22. Re: Letter - W.S. Adams, 6867 Broadway Sidewalk Crossings

Appearing on the Agenda for the August 14, 1972 Council Meeting is a letter from W.S. Adams objecting to abandonment of the driveway crossings at the subject location.

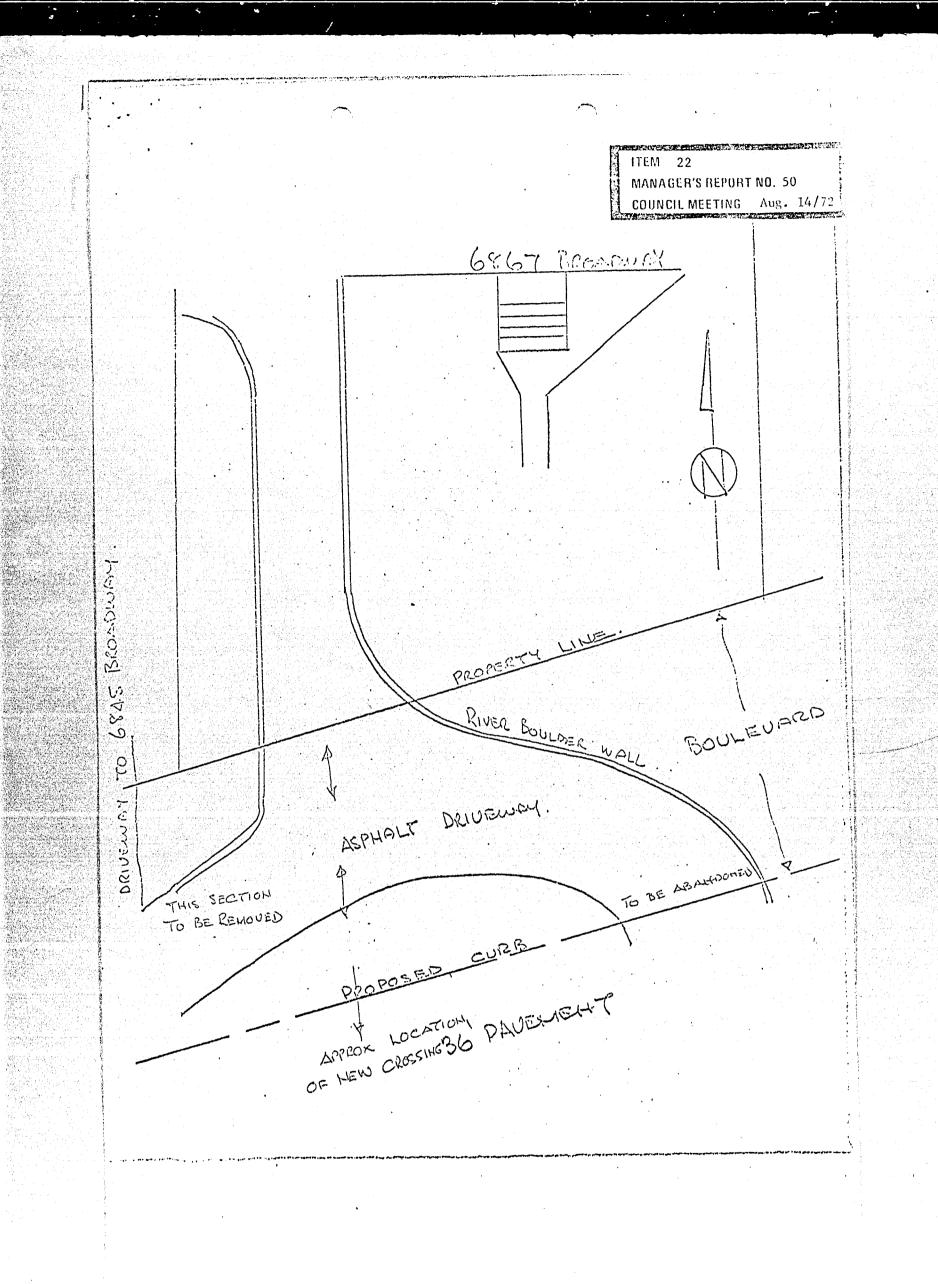
The Municipal Engineer advises that the reasons for denying a driveway crossing that would provide access to the present driveway locations (see <u>attached</u> sketch) are as follows:

- 1. The entire loop section of the driveway is outside the property and is located on the municipal boulevard.
- 2. The westerly leg of the loop crosses into the boulevard frontage of the property next door and will be connecting to their driveway. If this was permitted, it could be a source of complaint from the owner of 6845 Broadway either now or in the future.
- 3. Driving along a boulevard except when entering directly into a property on an approved driveway is a violation of Section 191, Provincial Motor Vehicle Act.

In view of the above, the Engineer seeks Council's concurrence that only one vehicle crossing in approximate alignment with applicant's main driveway be permitted.

THAT Council approve the proposed construction of only one vehicle crossing in approximate alignment with the applicant's main driveway; and
